STANDARD DEPARTURE CHART-INSTRUMENT

RJFN / NYUTABARU

NIPPO SEVEN DEPARTURE

SAITO ONE DEPARTURE

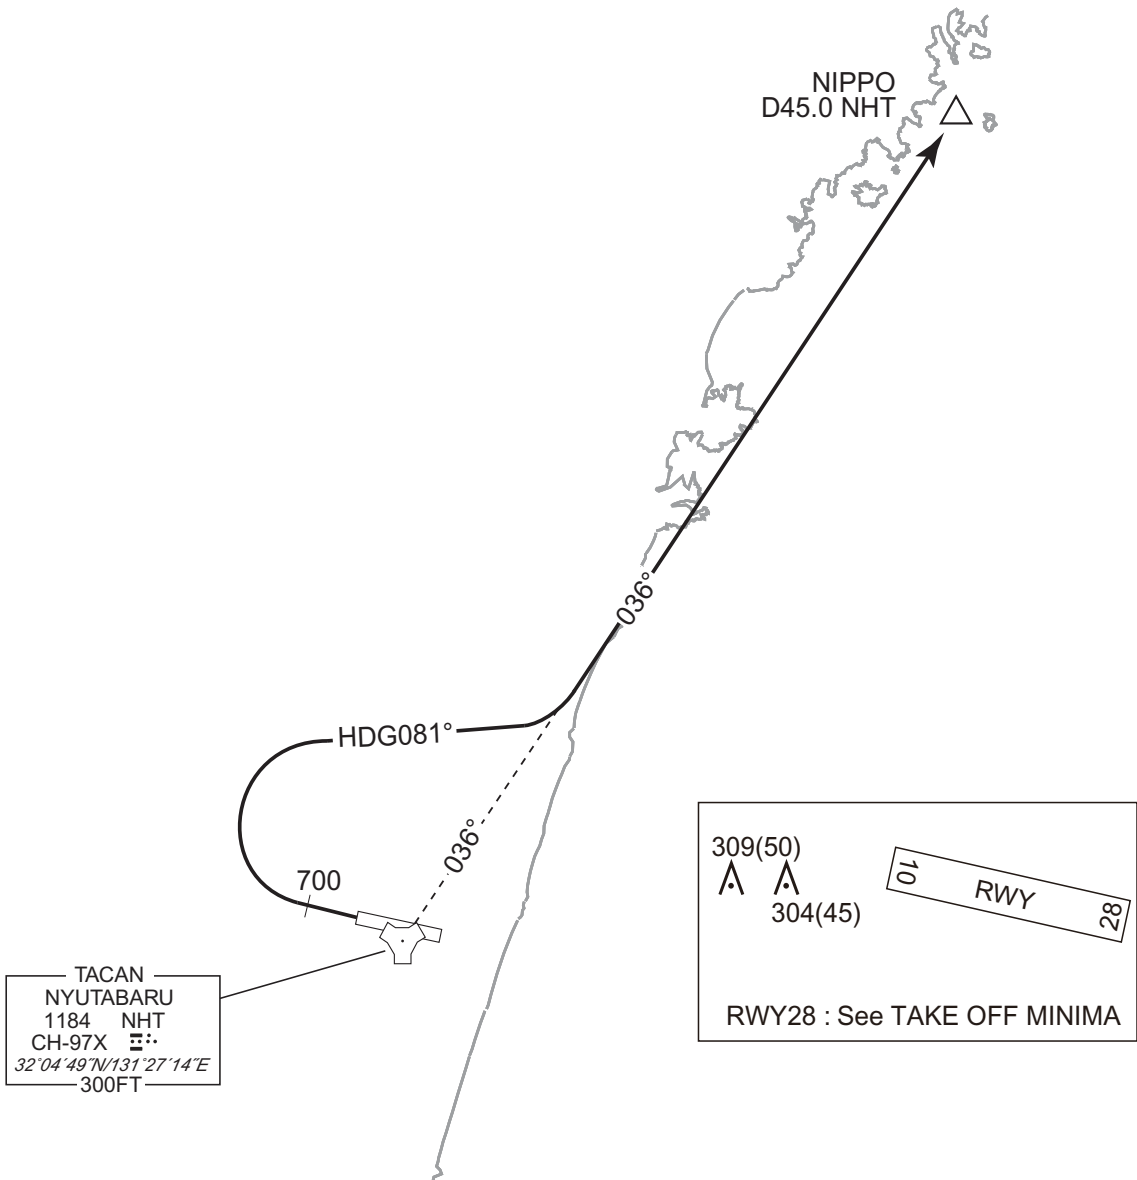
CHANGE : New PROC.

RJFN / NYUTABARU

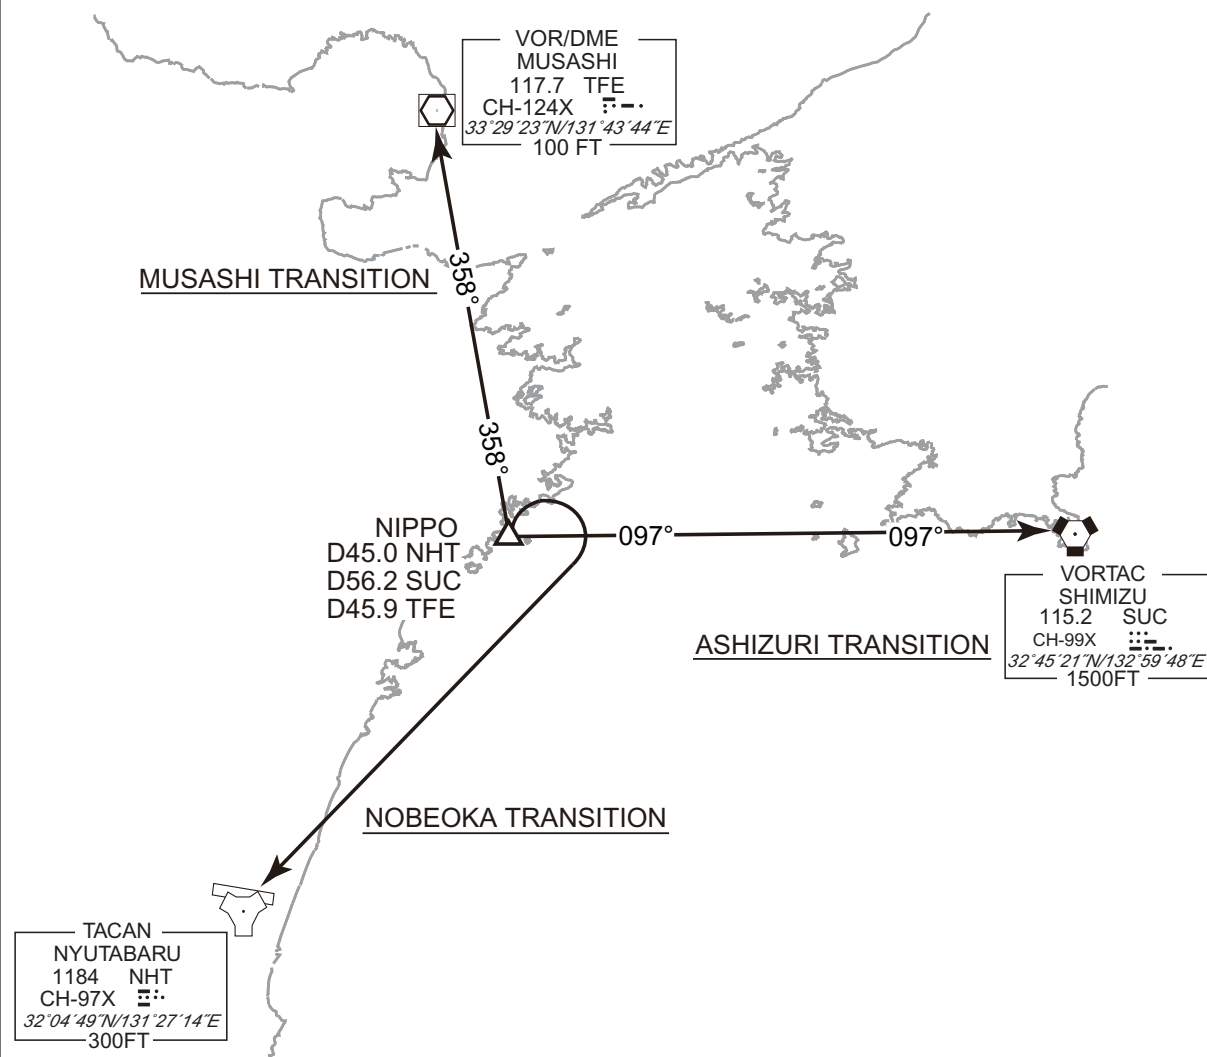
CHANGE : PROC course(NOBEOKA TRANSITION). Description of ASHIZURI TRANSITION, MUSASHI TRANSITION. ALT restriction.
SOBO TRANSITION abolished.

TENSO ARRIVAL

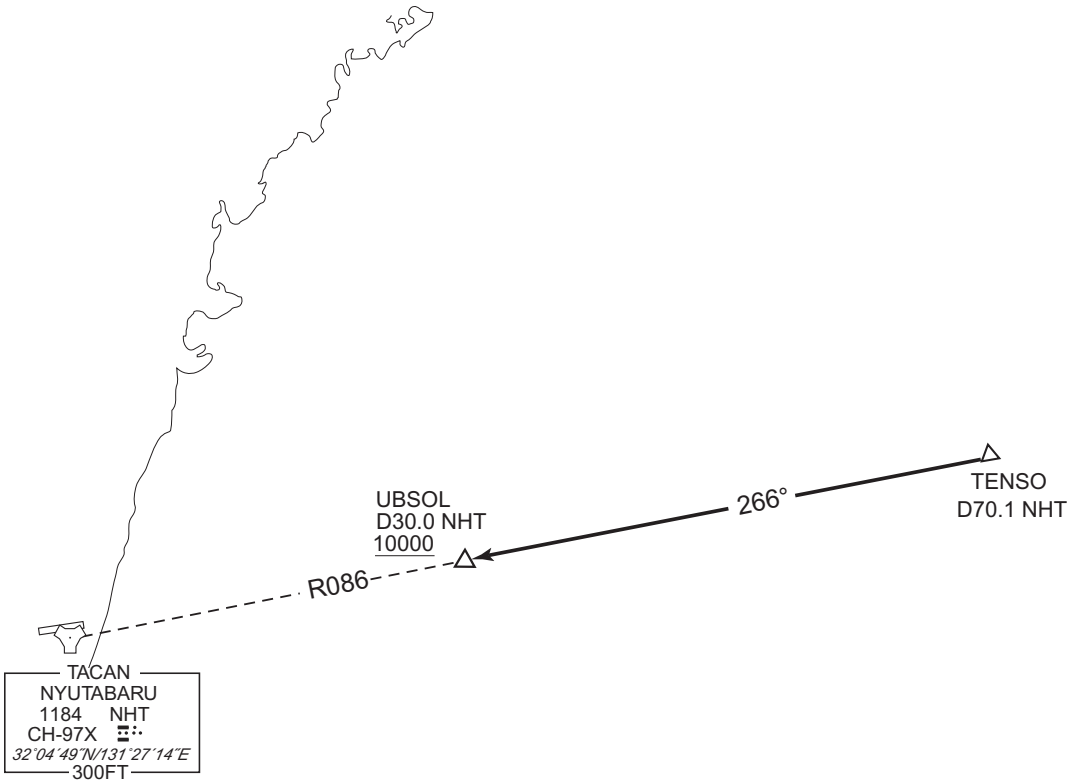
CHANGE : PROC course. UBSOL established. ALT restriction.

INSTRUMENT APPROACH CHART

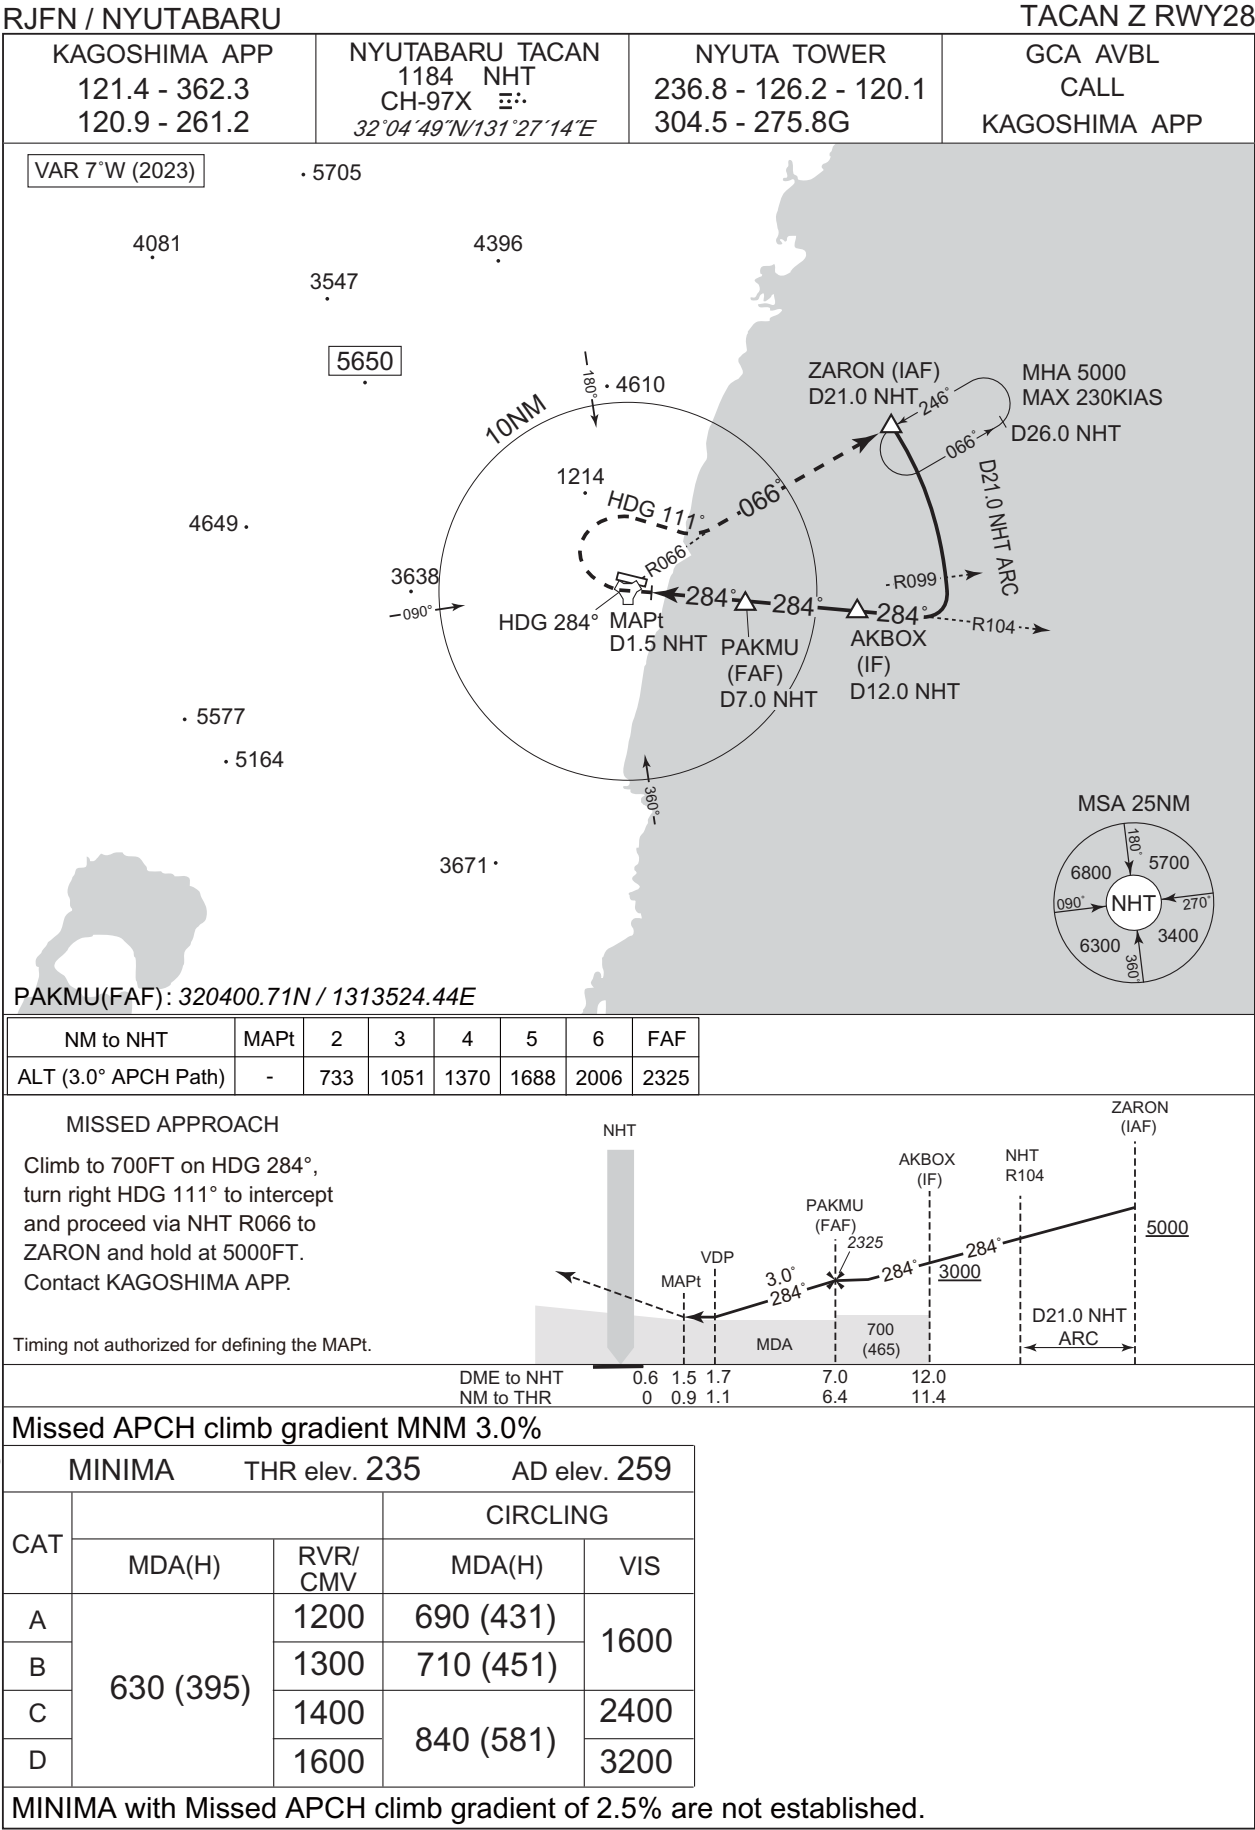
CHANGE : PROC course. Missed APCH course. MINIMA. PAKMU,AKBOX established. NM to THR. ALT(3.0°APCH Path), DME to NHT added.
Missed APCH climb gradient MNM added. VAR.

INSTRUMENT APPROACH CHART

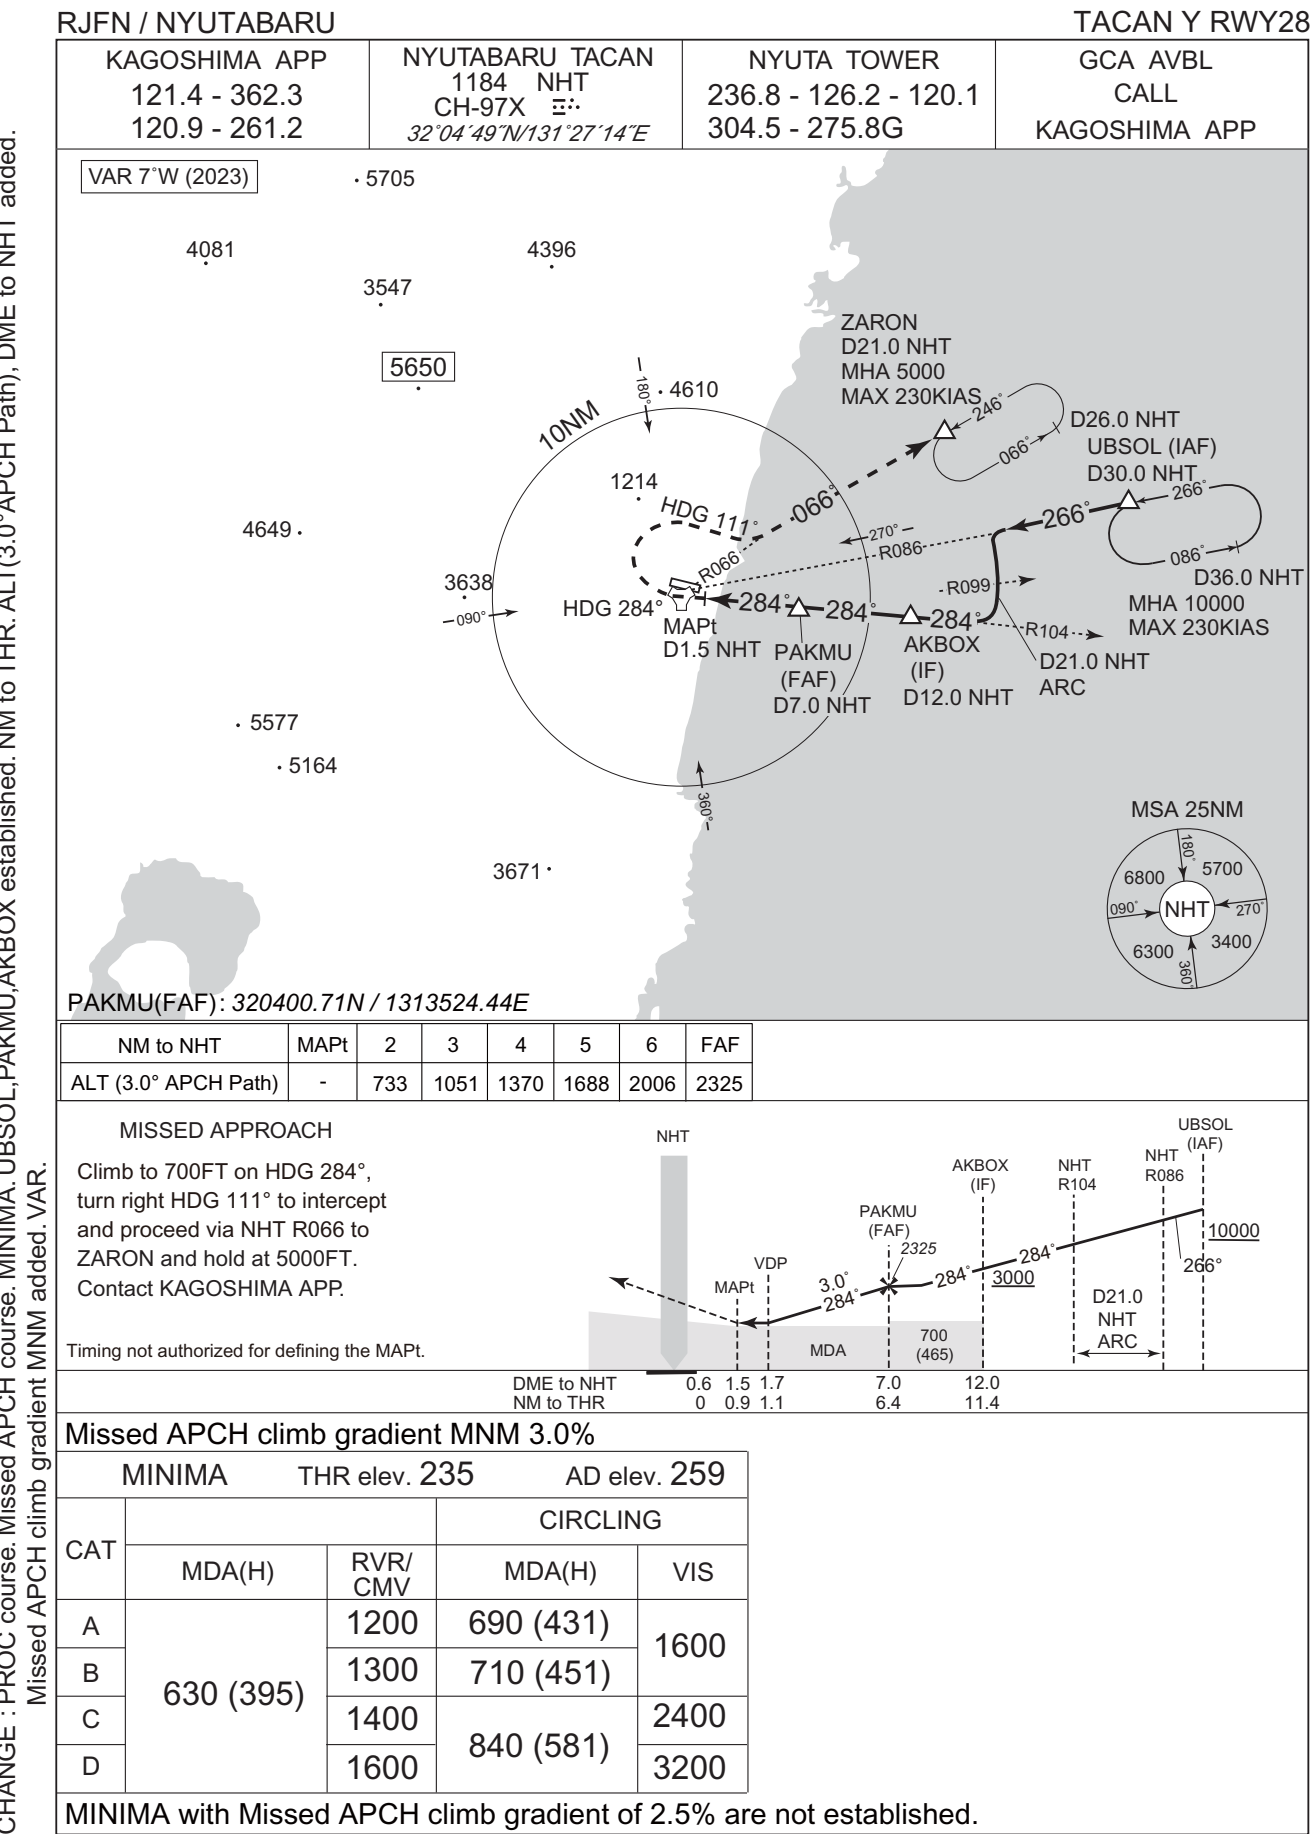
CHANGE : VAR. PROC renamed. EQPT REQUIRED added. PROC course. MISSED APPROACH course. MSA.
NM to THR added. MDA(H) for CIRCLING.

INSTRUMENT APPROACH CHART

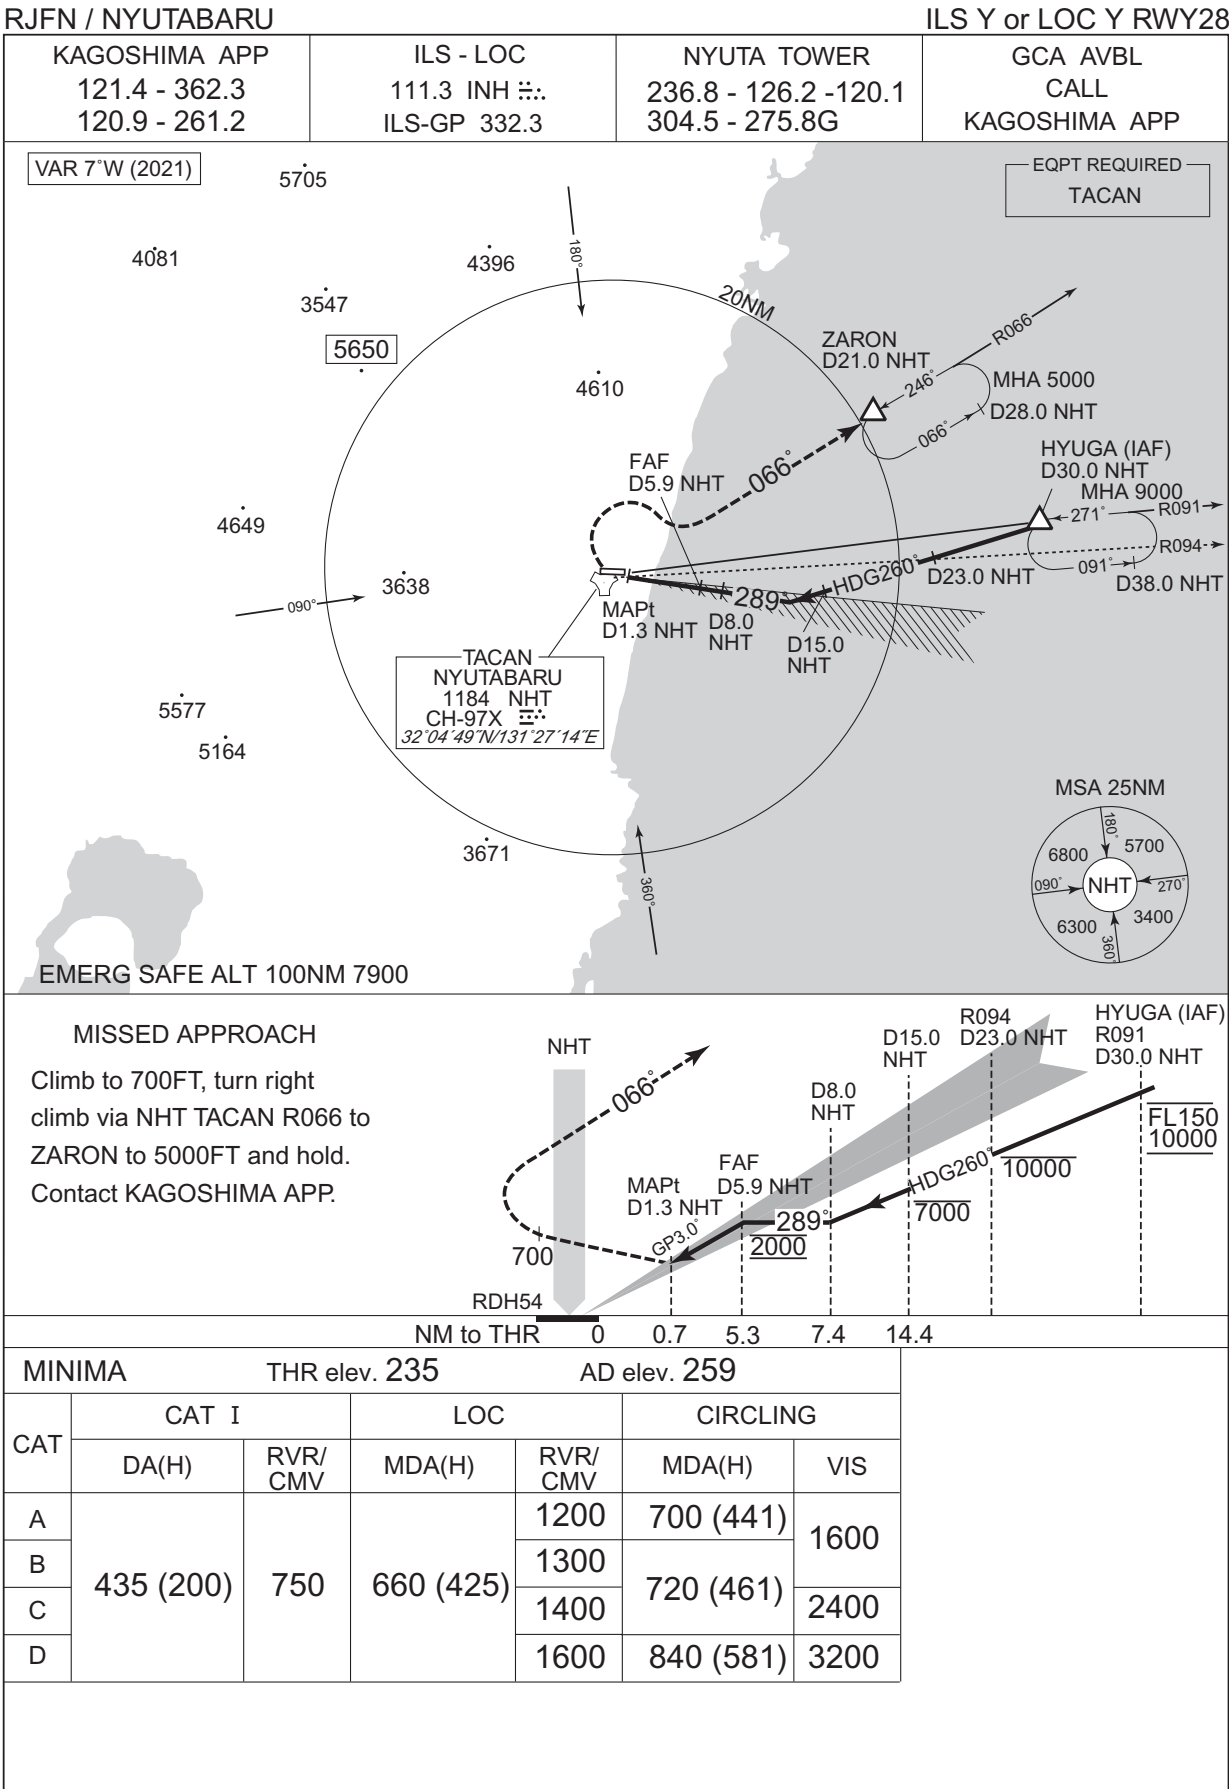
CHANGE : VAR. PROC renamed. EQPT REQUIRED added. PROC course. MISSED APPROACH course. MSA.
NM to THR added. MDA(H) for CIRCLING.
